Service Bulletin: SB 92

GAME: Junkyard

SUBJECT: Wrecking ball wire cable replacement

Wrecking Ball Chain Replacement Instructions

WRECKING BALL WITH CHAIN ATTACHED.

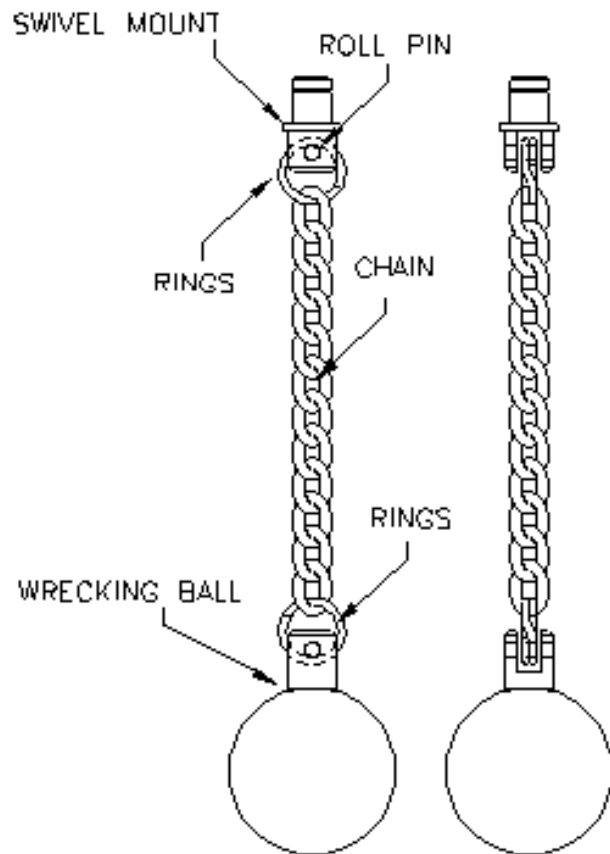
Because of a premature failure, the cable (p/n 04-10580.1) on the crane assembly is being replaced with a chain (p/n 04-10744).

5. Separate the rings (use a flat washer or a small coin to achieve this). Push the roll pin from the swivel mount between the rings and thread it all the way through to the end of the rings, as you would put a key on a key ring.
6. Do the same with the wrecking ball.

CHAIN p/n 04-10744

SEPARATE THE RINGS. PUSH THE ROLL PIN BETWEEN THE RINGS AND THREAD IT ALL THE WAY THROUGH TO THE END, JUST AS YOU WOULD THREAD A KEY ON A KEY RING.
